# Memorandum

To	Eugene White - Mulpha	Date	9 February 2018
Copies	Grant Bambach - Savilles George Cunha - Arup Glen Scott - Hassell	Reference number	252120
From	Peter Jameson - Arup	File reference	Memo_1_Existing_Rev3
Subject	Memo 1: Transport House – Additional Existing Building Assessment_Rev3

Please find below updated comments with respect to our assessment of the proposed ballroom extension the Transport House.

ELEVATION OF SOUTH WALL

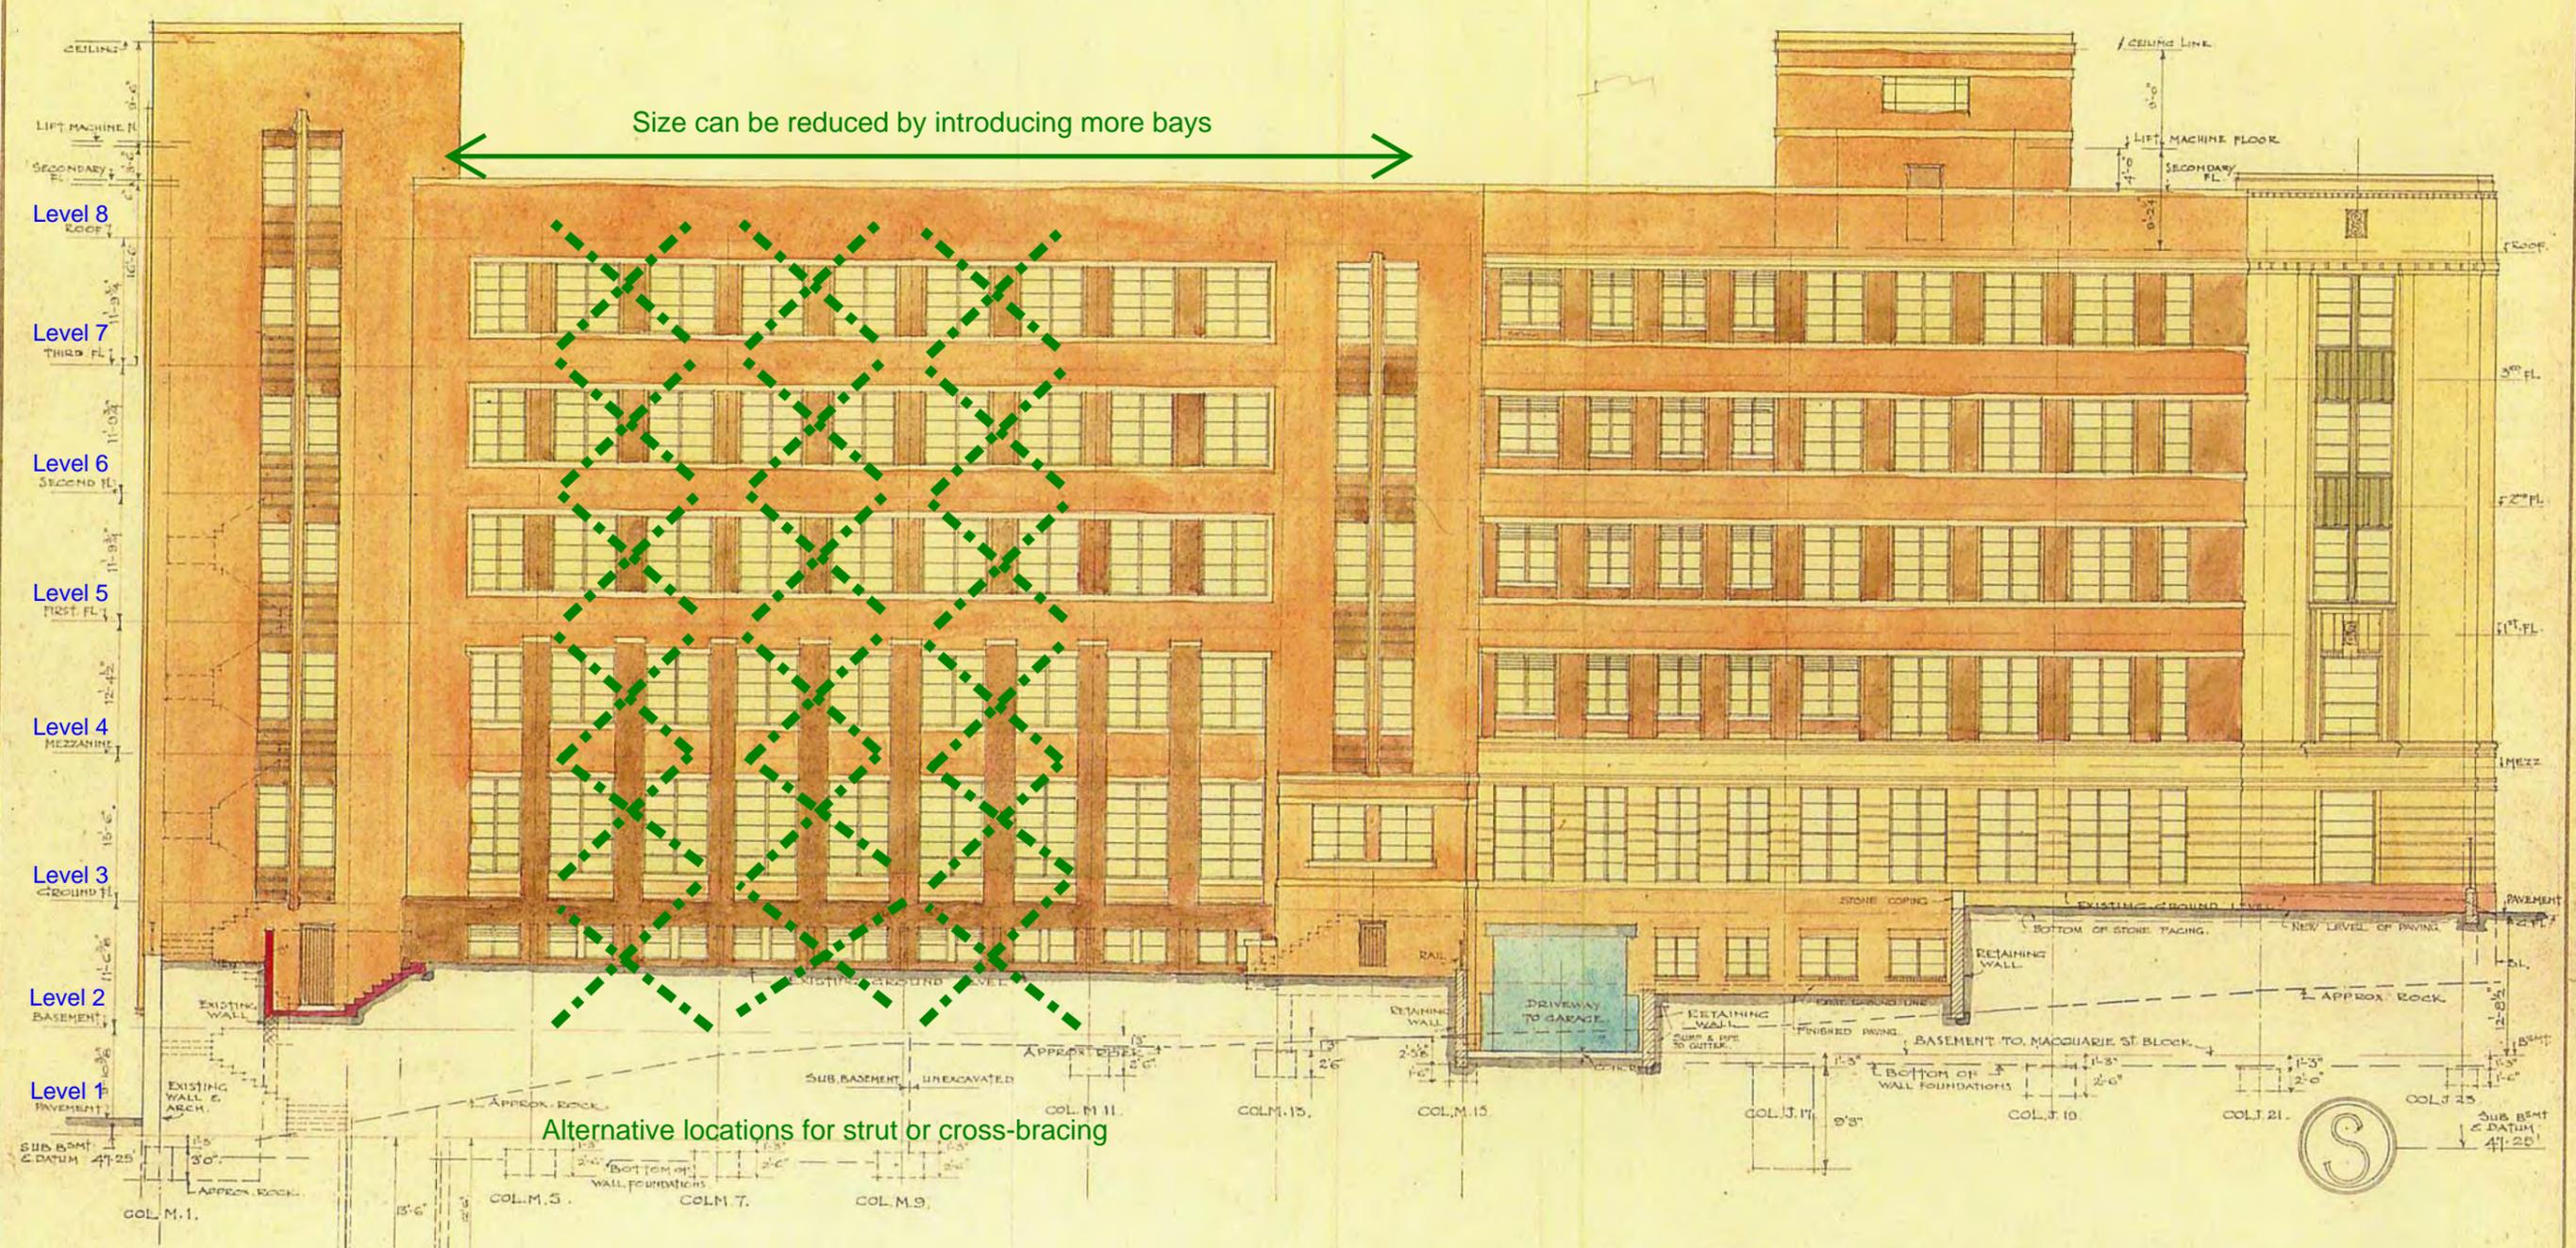
Alternative locations for strut or cross-bracing

ELEVATION OF NORTH WALL

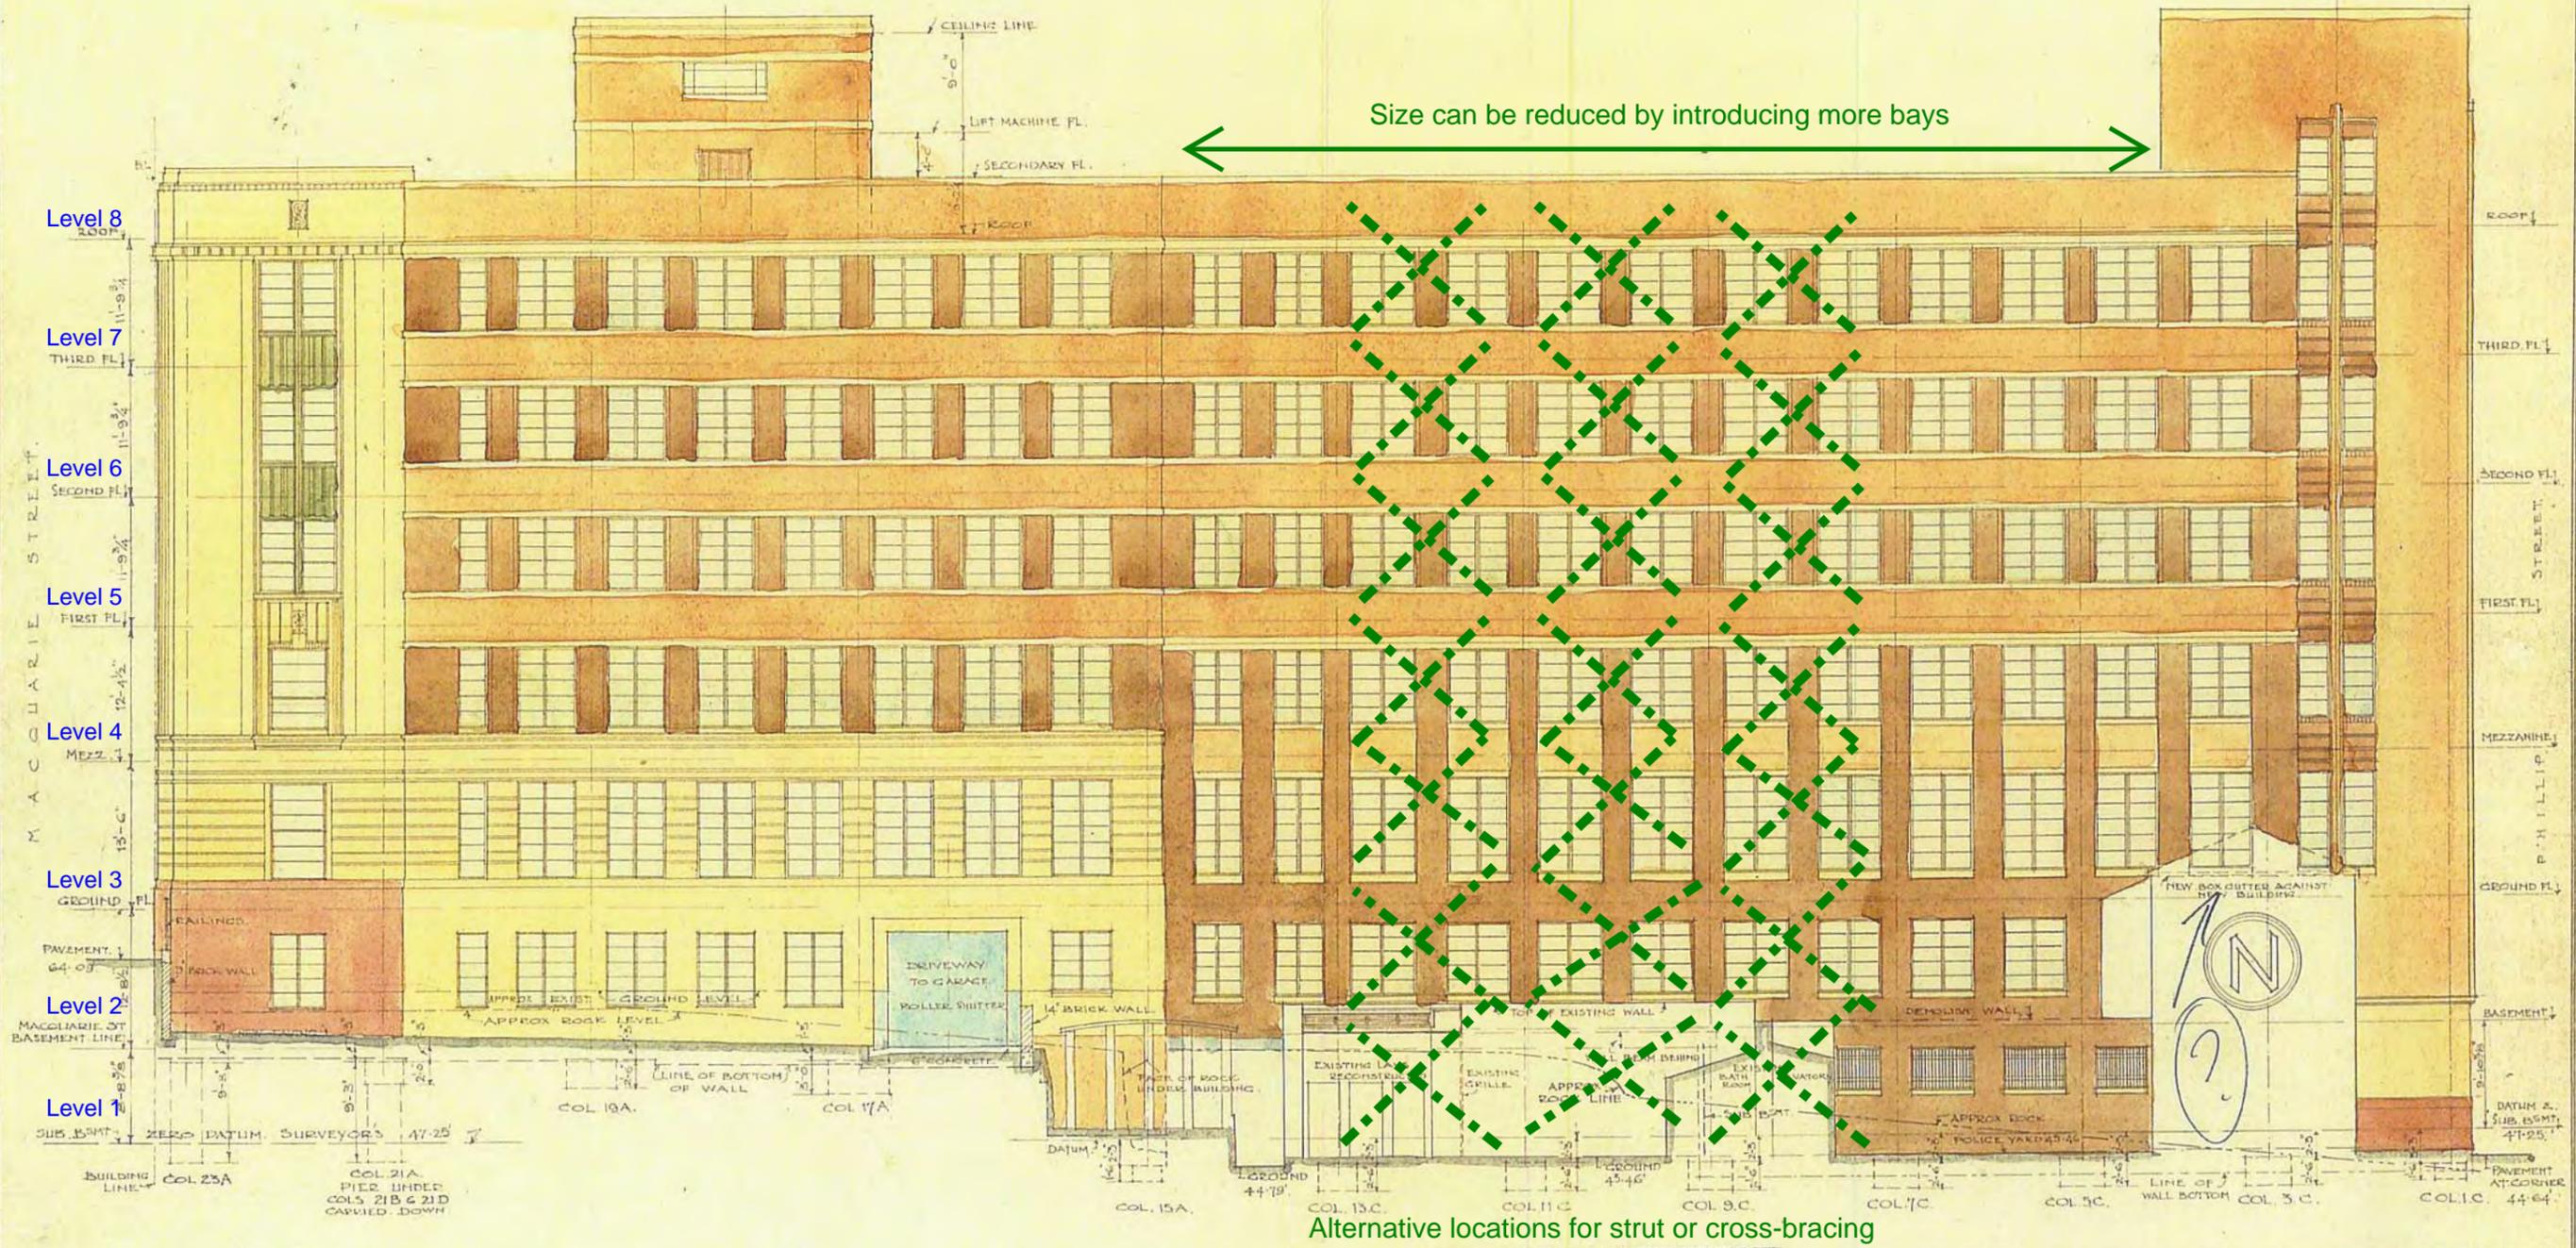
Alternative locations for strut or cross-bracing

Example of cross-bracing at facade and CHS  
'A' bracing internally at Grid 11-13/M-K at  
Ground (L3)

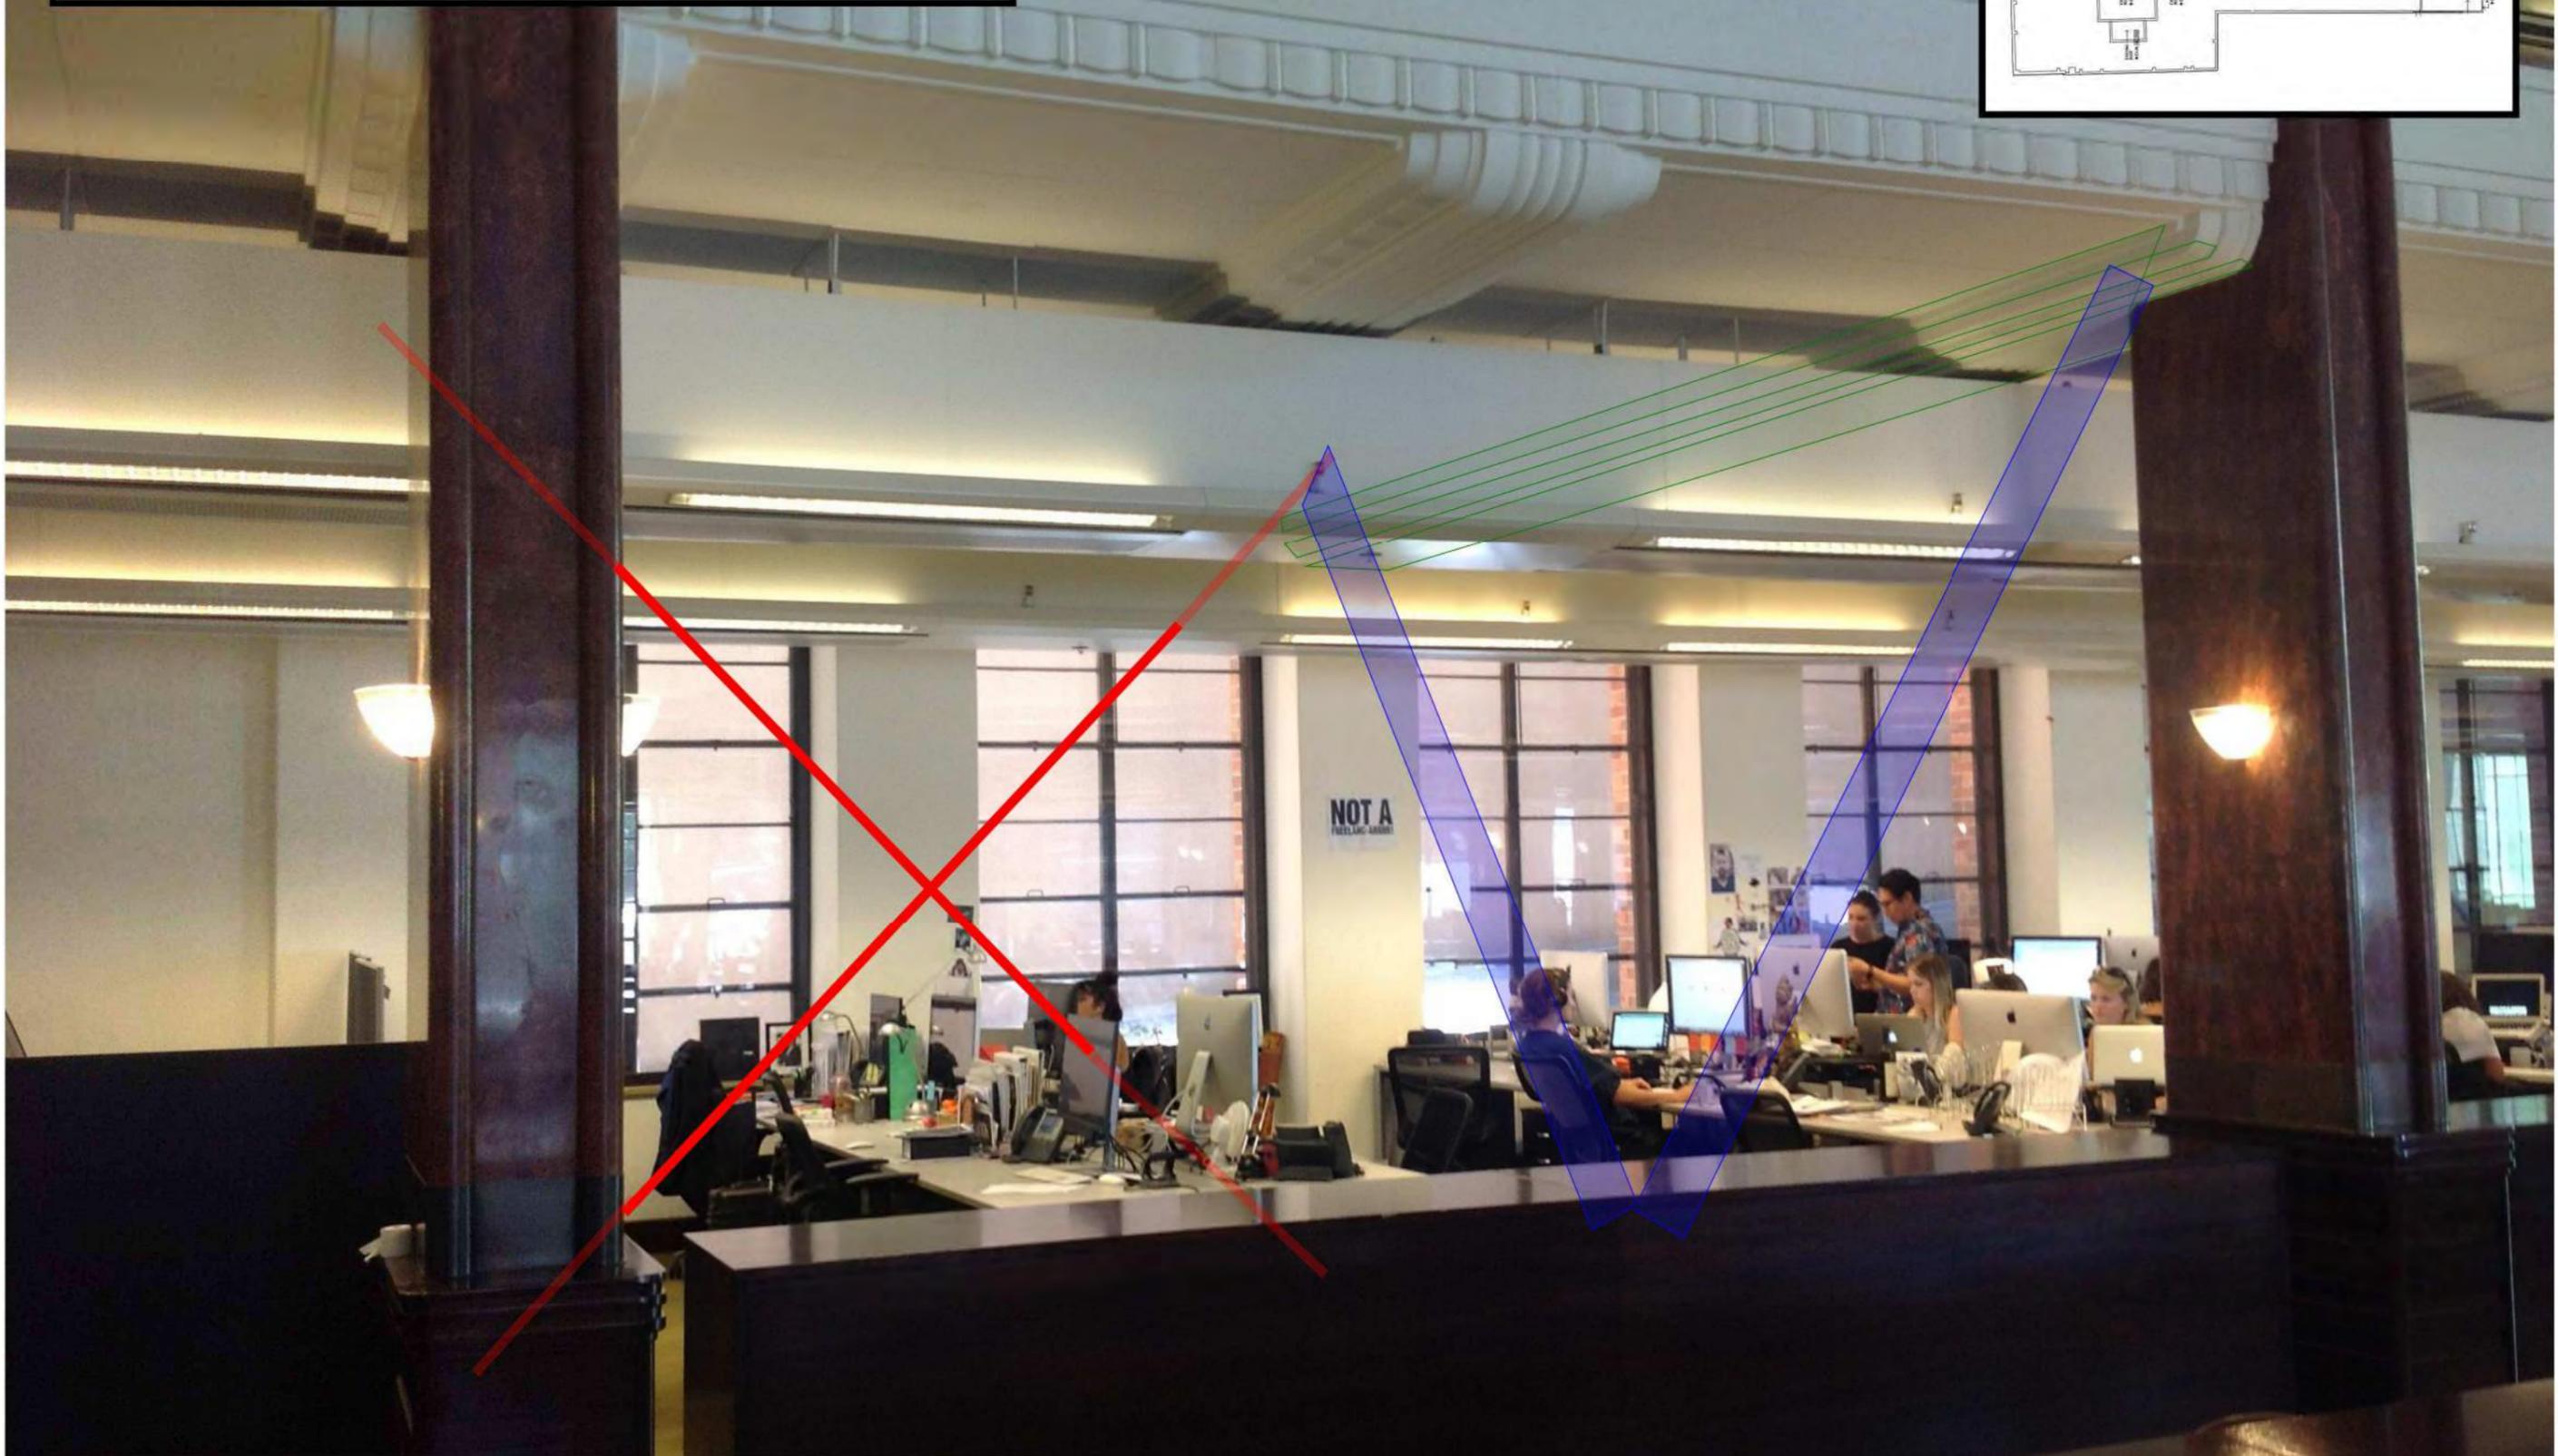
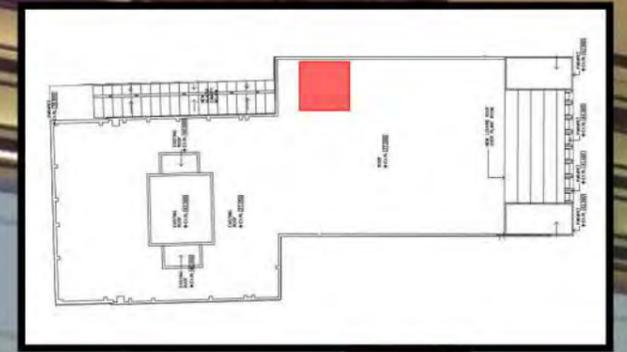
Note that the structural columns are every  
alternate facade vertical frame. Cross-bracing  
will be arranged as shown.

Bracing may be inverted to be  
an 'A' instead of a 'V'
